Service Bulletin

Subject: RNS0600 Ice Breaker

NUGGET ICE BREAKER REPLACEMENT PART

Latest Wiper Version 4 3/16” Wide

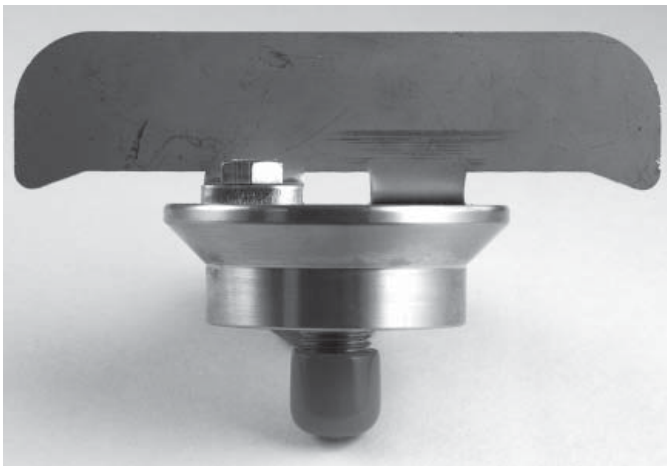
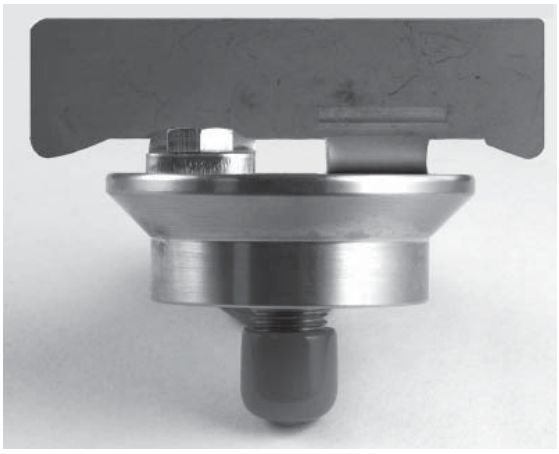
The ice breaker has been modified for improved ice delivery from the ice exhaust to the ice chute. Serial number M08249152017 is the start date for manufactured products with this newest version ice breaker

If you are experiencing an issue with ice collecting in the cover above the evaporator (ice exhaust) on models RNS0608A or RNS0609W with a serial number prior to M08249152017 replace the ice breaker. Order part number 000012897 and replace the ice breaker using the standard warranty procedure.
